# MANAGEMENT OF CHANGE **GUIDE**

## Replacement of Fisher® A11 High-Performance Butterfly Valve with Fisher 8590 High-Performance Butterfly Valve

Figure 1: Fisher A11 Valve

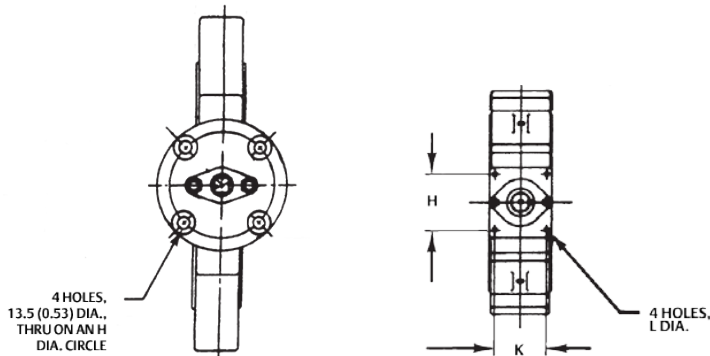
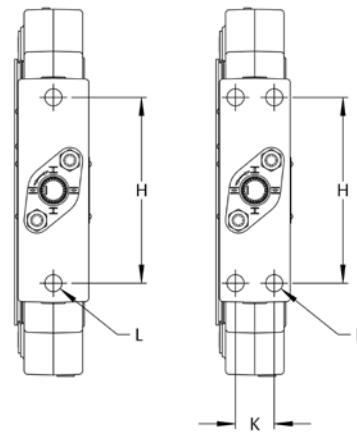
The NPS 3 to 6 A11 valves use a circular actuator mounting bolt pattern and the NPS 8 to 24 A11 valves use a rectangular actuator mounting bolt pattern. These bolt patterns require special brackets, yokes, or adapter pieces to mount Fisher actuators. The 8590 valve uses the Fisher style F mounting pattern and a spline shaft, as standard, which will mount easily to Fisher actuators. Square (NPS 3 to 12) and keyed (NPS 14 to 24) shaft options are available for mounting ISO 5211 actuators.
